HYUNDAI
Technical Service Bulletin

GROUP BODY ELECTRICAL	NUMBER 25-BE-022H
DATE DECEMBER 2025	MODEL(S) IONIQ 6 (CE EV)

SUBJECT: INOPERATIVE HORN ASSEMBLY REPLACEMENT
(WARRANTY EXTENSION Z13)

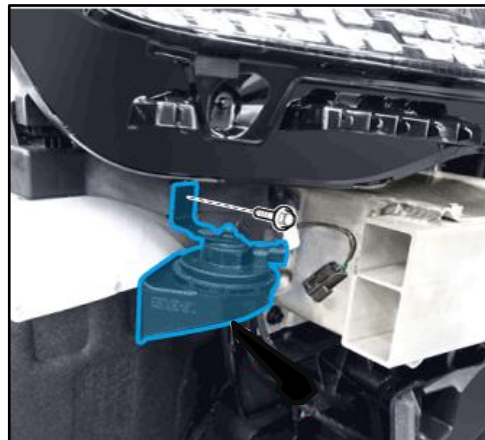
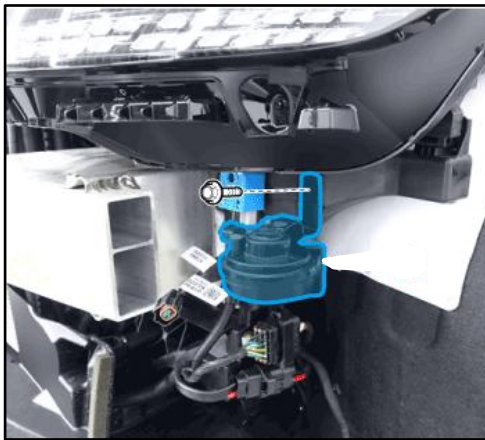
Description: Certain IONIQ 6 (CE EV) vehicles may have an inoperable horn that may be caused by water intrusion through the ventilation hole.

Model	Part Name	Part Number	Figure	Quantity
IONIQ 6 (CE EV)	Horn Assembly (Low)	96611-KL100QQH		1
	Horn Assembly (High)	96621-KL100QQH

Hyundai is extending the warranty coverage for the horn replacement to 10 years/120,000 miles from the date of original retail delivery or date of first use (whichever occurs first) and is valid for original and subsequent owners.

This bulletin provides instructions on the replacement of the inoperative horn.
